# **Product Change Notification**

## **114070 - 00**

**Change Notification #:** 114070 - 00  
**Change Title:** Intel® Server System R1304GZ4GS9  
PCN 114070-00, Update the Quick Reference  
Label and the Safety Label  
**Date of Publication:** September 11, 2015

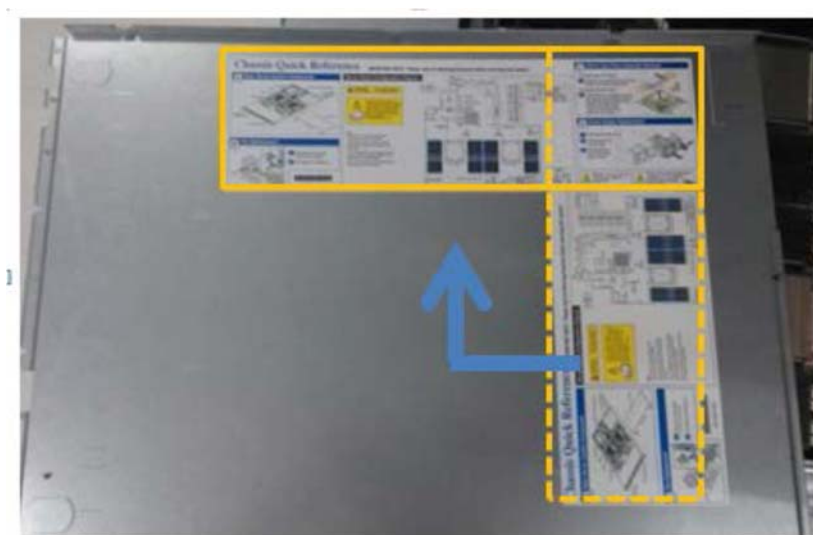
- Rotate the orientation of the Quick Reference Label by 90 degree. The new location of the label is above the power supply unit cage and the air duct. Please see the figure below for reference.

- Update the Safety Label: Put an EAC logo instead of a GOST logo for certification update. A sample Safety Label is as below.
